**PLANNED UNIT DEVELOPMENT &
SUBDIVISION STAFF REPORT**

Date: August 6, 2015

<u>NAME</u>	Southport Industrial Estate, LLC Subdivision
<u>SUBDIVISION NAME</u>	Southport Industrial Estate, LLC Subdivision
<u>LOCATION</u>	4077 Hamilton Boulevard (South side of Hamilton Boulevard, 2/10± mile West of Rangeline Road).
<u>CITY COUNCIL DISTRICT</u>	District 4
<u>AREA OF PROPERTY</u>	2 Lots / 43.3± Acres
<u>CONTEMPLATED USE</u>	Subdivision to create two legal lots of record, and Planned Unit Development Approval to allow multiple buildings on a single building site
<u>TIME SCHEDULE</u>	None provided

SITE PLAN

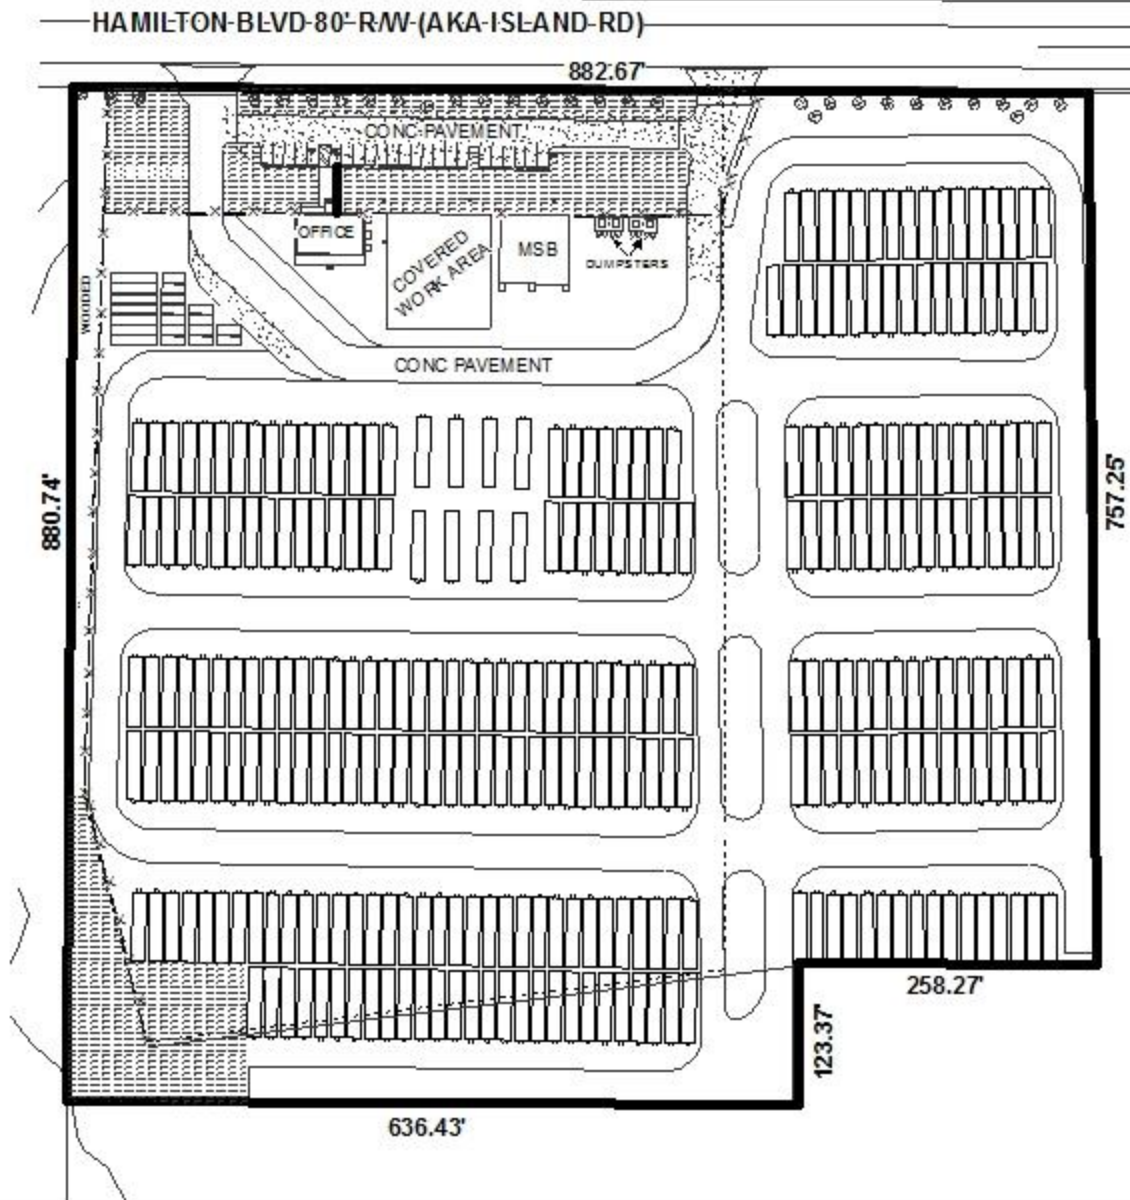
The proposed Lot 1 currently operates as a shipping container storage yard and will be developed with three structures. The site plan submitted states that one structure will be used as office space, but does not provide the use of the other two structures. The use of all structures and number of warehouse employees, if applicable, should be provided so that staff can determine if the proposed 23 parking spaces are sufficient.

The site plan illustrates full compliance with landscape area requirements, as well as frontage trees which are all that is required an I-2, Heavy Industry District.

- 1) provide the uses of the existing structures on site and number of warehouse employees, if applicable.

DETAIL SITE PLAN

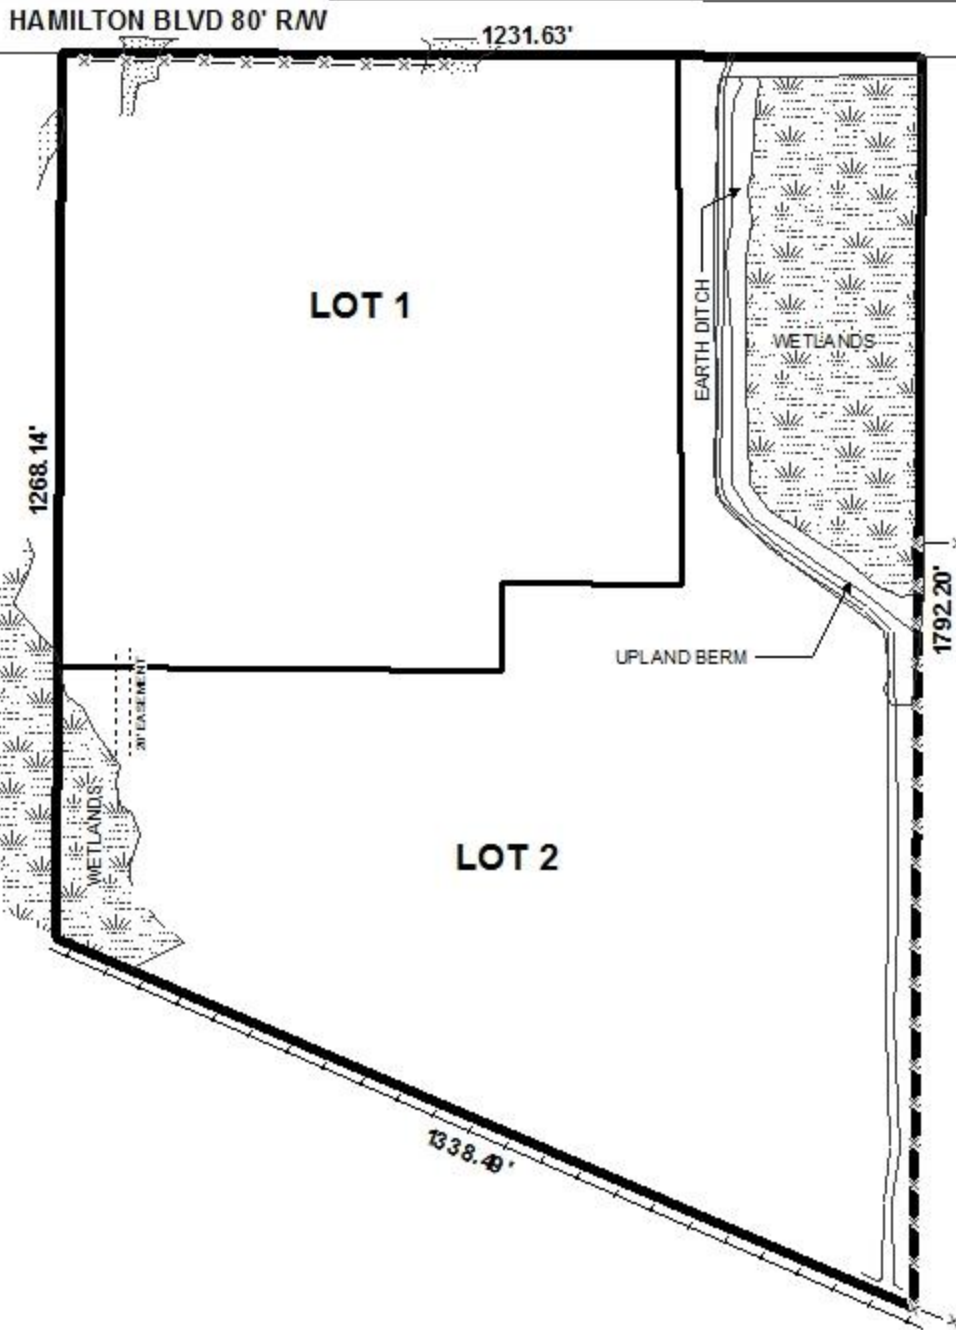
The applicant wishes to create two legal lots of record from two metes-and-bounds parcels. It should be noted however, that the preliminary plat submitted appears to be including a portion of a parcel to the South of the site (R023801380000035.) which does not appear to be owned by the applicant. If this is accurate, the applicant should revise the application to include the entire parcel to the South, and submit revised application fees, mailing labels, and appropriate authorization.

The proposed lots, as depicted, meet the minimum size and frontage requirements as regulated by the Subdivision Regulations. The lot area sizes are depicted on the plat in square feet and acres. The lot sizes should be retained in square feet and acres on the Final Plat, if approved. The 25-foot minimum building setback line is not depicted, and should be illustrated on the Final Plat, if approved.

The lot fronts Hamilton Boulevard, a proposed major street, which should have a right-of-way of 100'. The preliminary plat illustrated an existing right-of-way width of 80', making dedication necessary to provide 50' from the centerline. As a means of access management, a note should be placed on the site plan and Final Plat stating that Lot 1 is limited to the two existing curb cuts to Hamilton Boulevard, and Lot 2 is limited to one curb cut to Hamilton Boulevard with size, location and design to be approved by Traffic Engineering and conform to AASHTO standards.

- 1) revision of the preliminary plat to either include the entire parcel to the South (R023801380000035.), or remove the included portion; and
- 2) submittal of revised fees, mailing labels, and appropriate authorization, if necessary.
